SUBJECT: PENNSYLVANIA STATE UNIVERSITY – ISSUANCE OF AMENDMENT NO. 43
TO RENEWED FACILITY OPERATING LICENSE NO. R-2 TO AMEND THE
TECHNICAL SPECIFICATIONS FOR THE PENN STATE BREAZEALE
REACTOR (EPID NO. L-2025-NFA-0004)

Amendment No. 43
License No. R-2

SAFETY EVALUATION BY THE OFFICE OF NUCLEAR REACTOR REGULATION

ORGANIZATION CHART

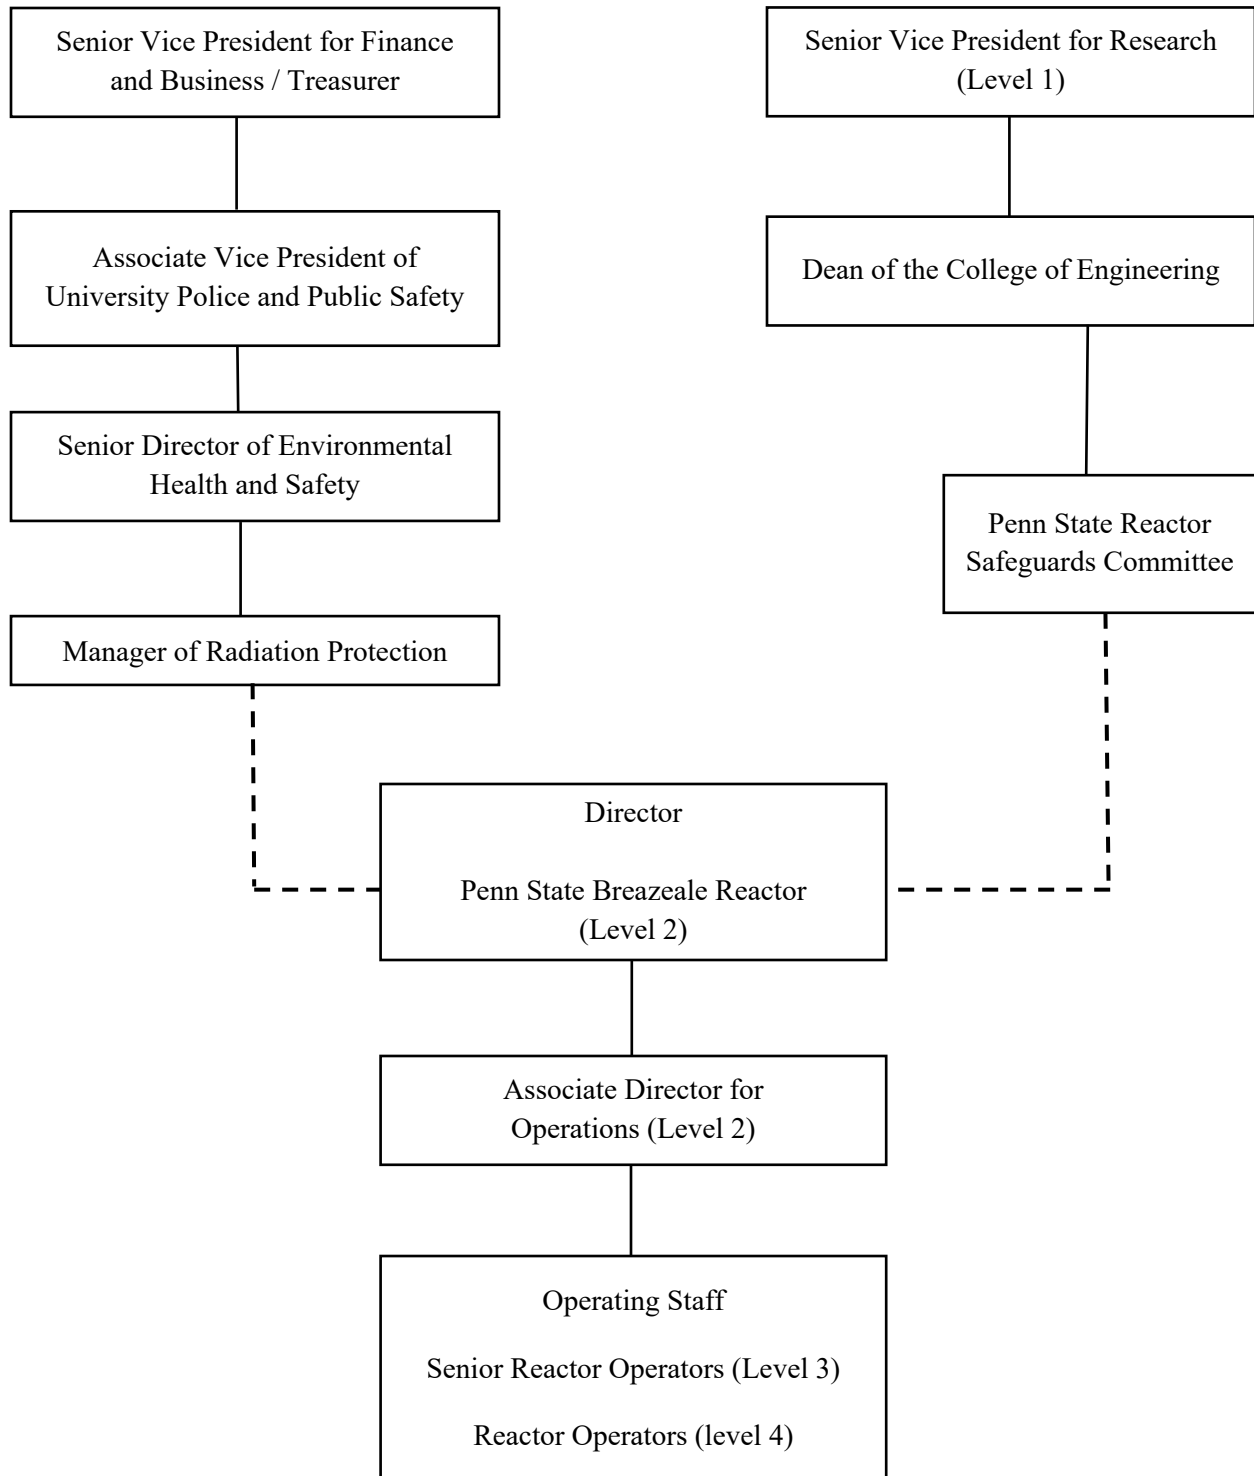
The Manager of Radiation Protection reports through the Senior Director of Environmental Health and Safety and the Associate Vice President of University Police and Public Safety, and to the Senior Vice President for Finance and Business/Treasurer. The qualifications for the Manager of Radiation Protection position are the equivalent of a graduate degree in radiation protection, 3 to 5 years experience with a broad byproduct material license, and certification by The American Board of Health Physics or eligibility for certification.

Responsibility for the safe operation of the reactor facility SHALL be within the chain of command shown in the organization chart. Individuals at the various management levels, in addition to having responsibility for the policies and operation of the reactor facility, SHALL be responsible for safeguarding the public and facility personnel from undue radiation exposures and for adhering to all requirements of the operating license and technical specifications.

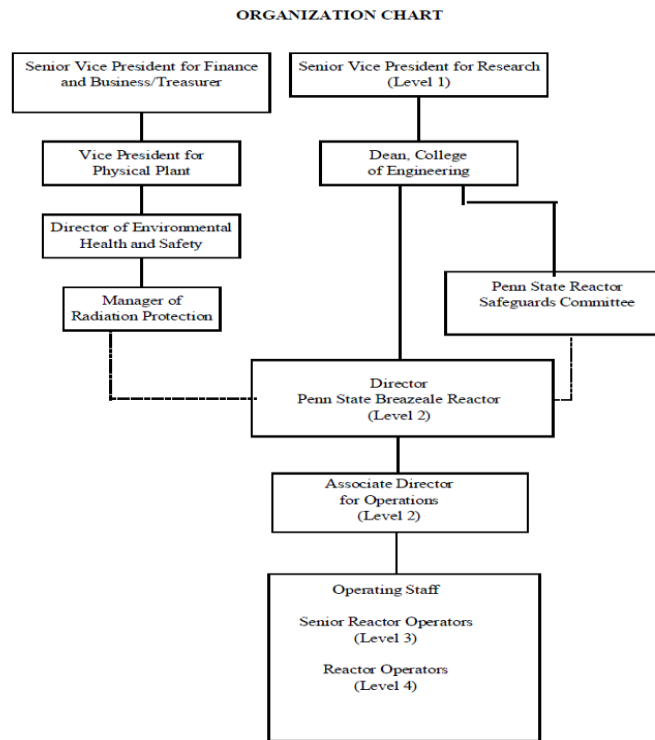
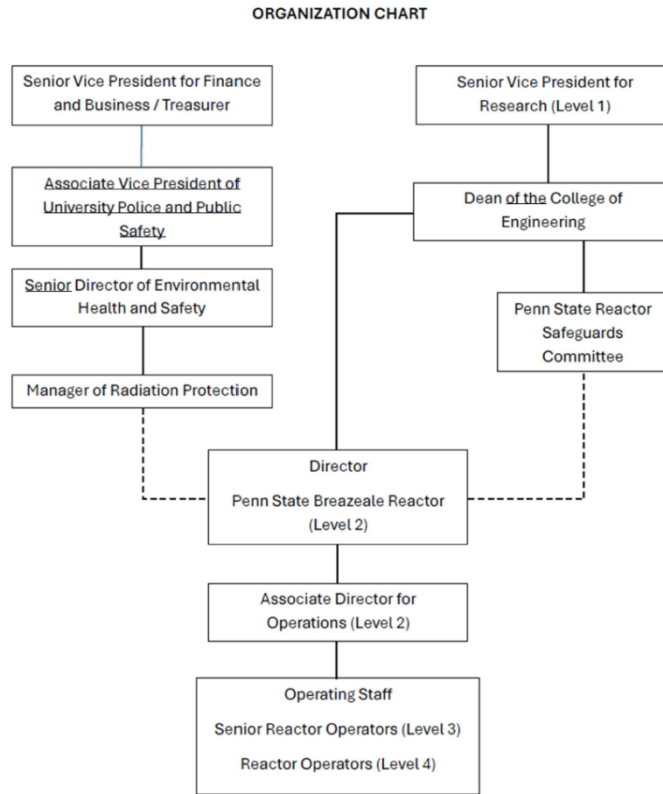
The licensee proposed to revise TS 6.1.2 to change the facility Organization Chart to reflect the proposed changes to TS 6.1.1. Specifically, these changes would update "Director of Environmental Health and Safety" to "Senior Director of Environmental Health and Safety," remove "Vice President for Physical Plant," and add "Associate Vice President of University Police and Public Safety" to the management organizational structure for the Manager of Radiation Protection. During a discussion on May 7, 2025 (ML25129A007), the licensee also confirmed its intent to make an editorial revision to the Organization Chart to change the title of "Dean, College of Engineering" to "Dean of the College of Engineering."

Current TS 6.1.2 states, in part:

Proposed TS 6.1.2 would state, in part:

The NRC staff reviewed the proposed TS 6.1.2 Organization Chart and finds that it is consistent with the guidance in NUREG-1537, Part 1, section 12.1.5, "Radiation Safety," and Part 2, section 12.1, "Organization," because the chart continues to provide a management structure that ensures that the radiation organization can report radiological safety issues to university management independent of facility operation management. The NRC staff also finds that the proposed changes to TS 6.1.2 ensure consistency with proposed TS 6.1.1, which was found to be acceptable as described in section 3.1.1 of this safety evaluation. The NRC finds that the proposed change from "Dean, College of Engineering" to "Dean of the College of Engineering" is editorial and, therefore, acceptable. Because the proposed changes to TS 6.1.2 are consistent with guidance and provide administrative controls relating to organization, management, review, and reporting that are necessary to assure operation of the facility in a safe manner as required by 10 CFR 50.36(c)(5), the NRC staff finds the proposed changes acceptable.
